Re: Newfoundland & Labrador Hydro's 2003 Capital Budget Application

Enclosed please find fifteen (15) copies of Newfoundland and Labrador Hydro's responses to Requests for Information numbers PUB 1.0 to PUB 9.2.

**Evaluation of Options to
Upgrade Stack Liner #1**

Cumulative Worth Comparision

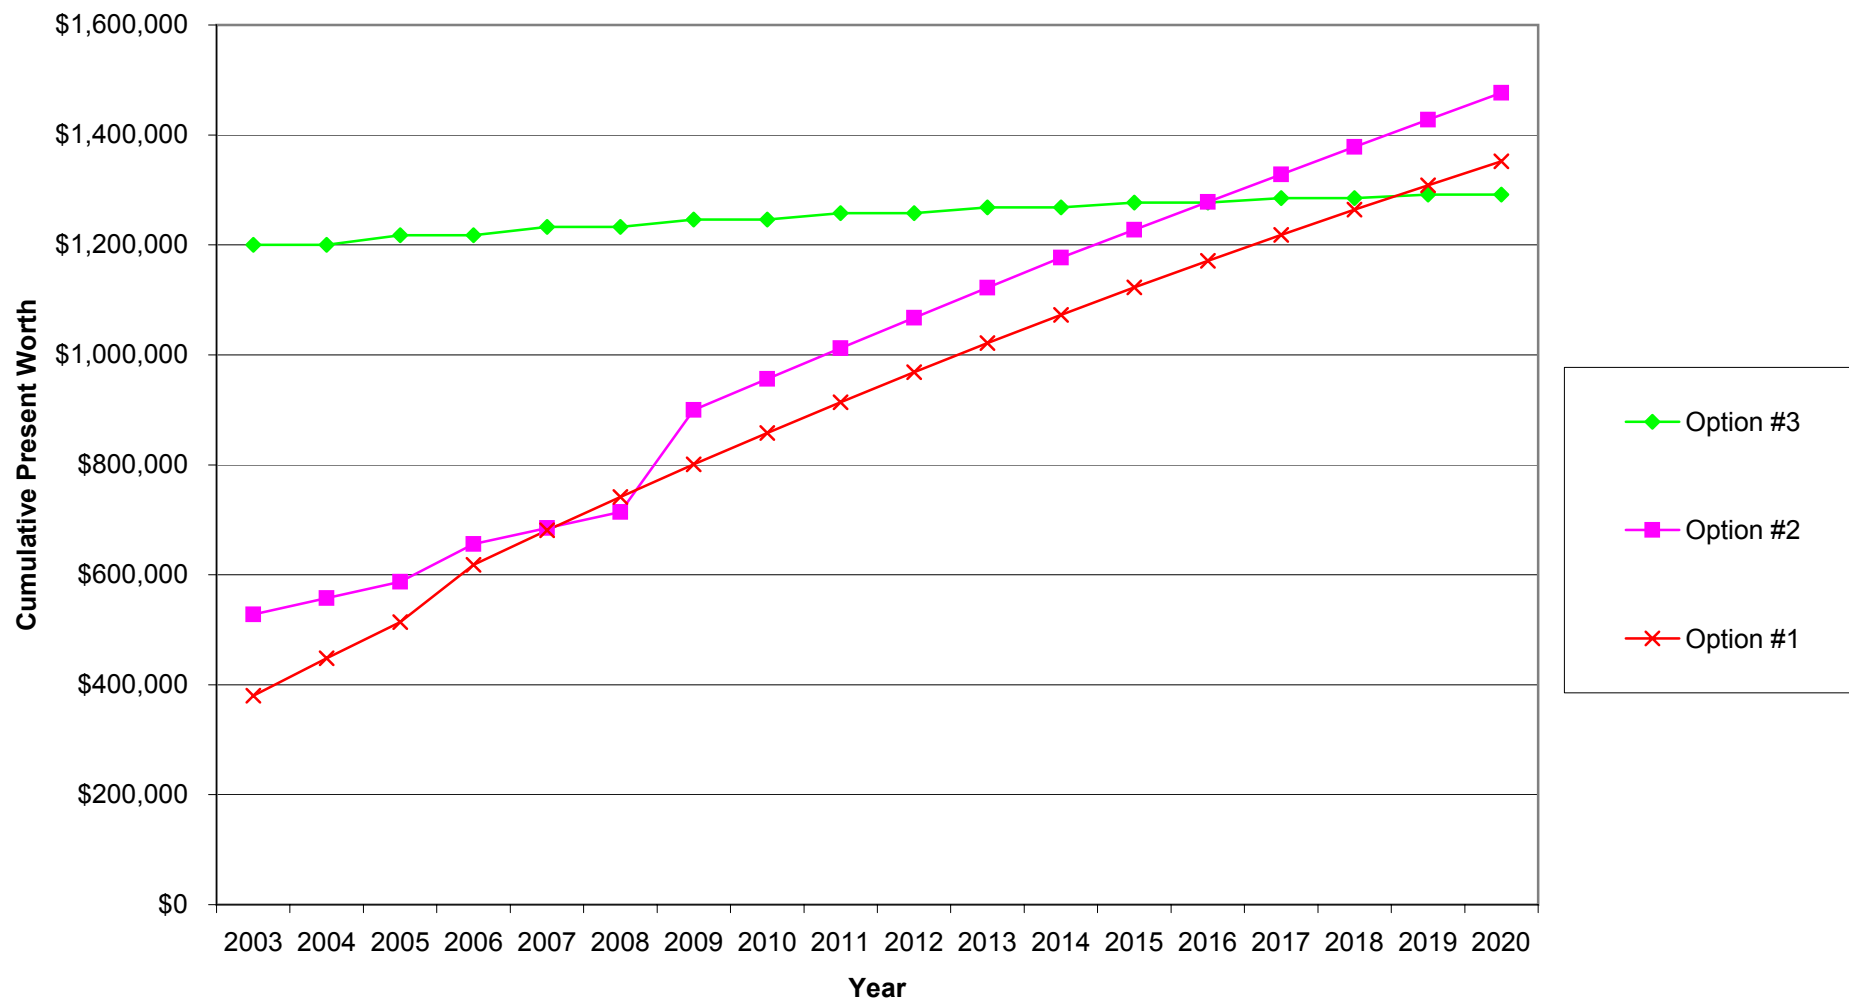
3 3.1 Provide a summary of the evaluation of the options considered to
4 upgrade the steel liner.

7 A. 3.1 Please see the attached summary of the review done regarding the
8 replacement of the stack steel liner.

The results of this calculation revealed that the replacement of the stack liner is the least cost option over the 18-year evaluation period. The results of this comparison are shown in Appendix A, Cumulative Present Worth Comparison.
